**ROAD LAYOUT
HOUSING DEVELOPMENT
FROGSTON ROAD (POD I)
EDINBURGH**

STAGE 3 ROAD SAFETY AUDIT
(SPA Ref No: 4282)

Roads Authority: The City of Edinburgh Council

Client: Barratt Homes

Annex 2 PROBLEM LOCATION PLAN

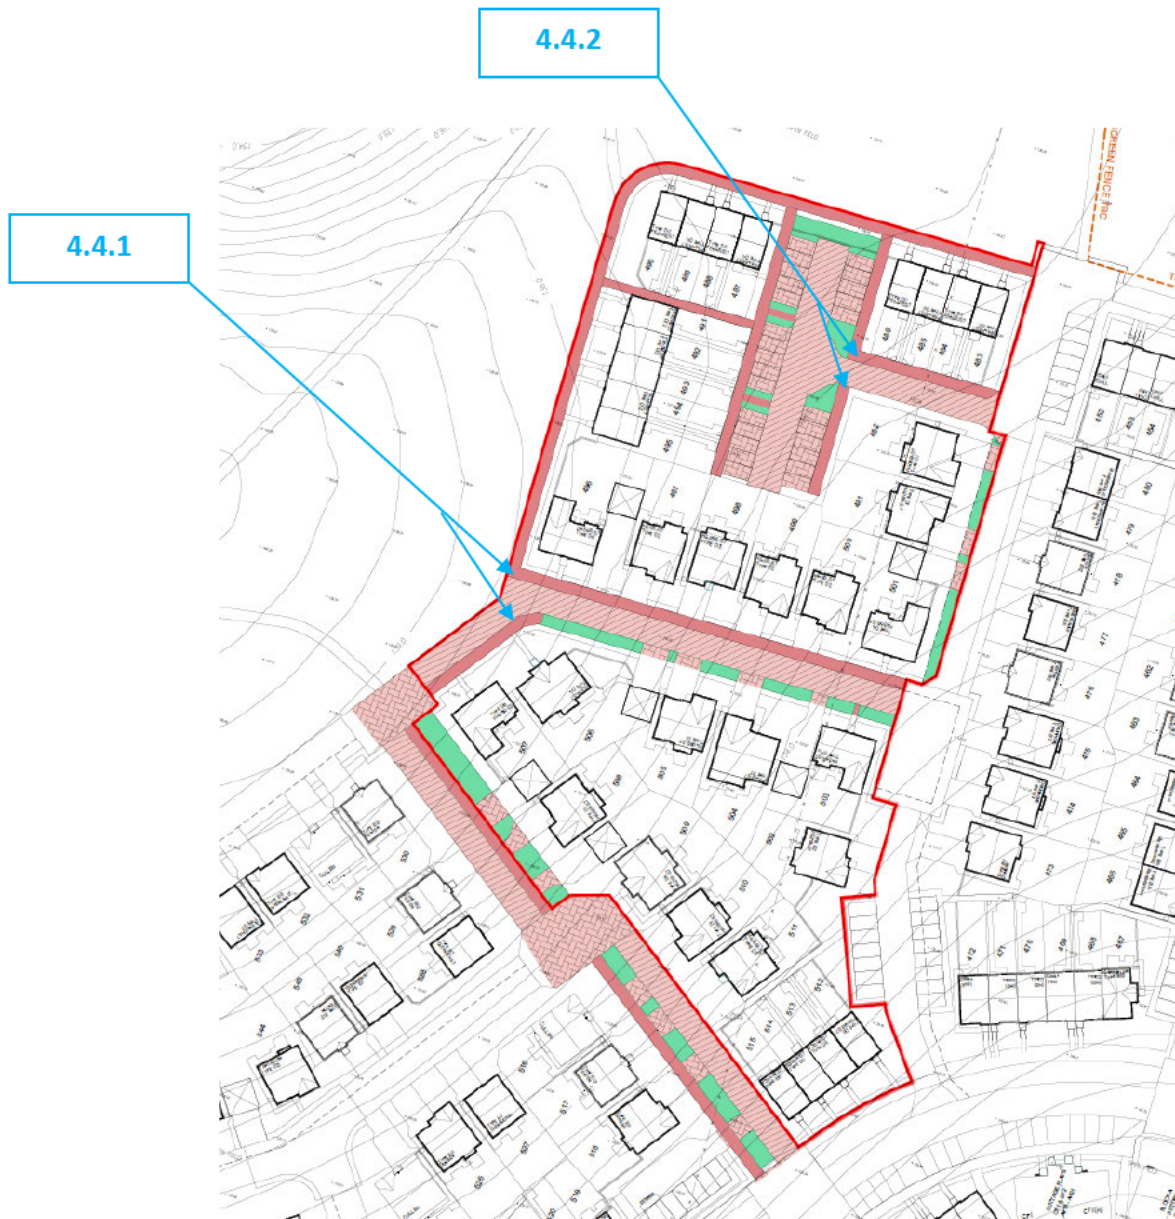
4.4.1 PROBLEM

Location: West end of Arkaig Gardens

Drawing(s): E9876/1535 - A

Summary: Inaccessible footways can be hazardous for the less mobile, those in wheelchairs or those pushing buggies and increase the potential for tripping accidents.

At the west end of Arkaig Gardens the footpath running north to south from plots 490 to 496 meets the carriageway. There is no dropped kerb at this point or at the footway opposite that runs past plots 506 & 507. As such pedestrians seeking to use this pedestrian route will have to negotiate two full height kerbs.

4.4.2 PROBLEM

Location: Parking Court

Drawing(s): E9876/1535 - A

Summary: Inaccessible footways can be hazardous for the less mobile, those in wheelchairs or those pushing buggies and increase the potential for tripping accidents.

At the south-east run of parking at the parking court there is a footway running south to north. At the north end there is no accessible dropped kerb to assist with access. As such pedestrians seeking to use this pedestrian route will have to negotiate a full height kerb. If people were heading to this run of parking from Hepburn Gardens then they would have to negotiate two full height kerb

It is recommended that dropped kerbs be provided in a similar manner as to adjacent sections of footways.

It is recommended that dropped kerbs be provided in a similar manner as to adjacent sections of footways.
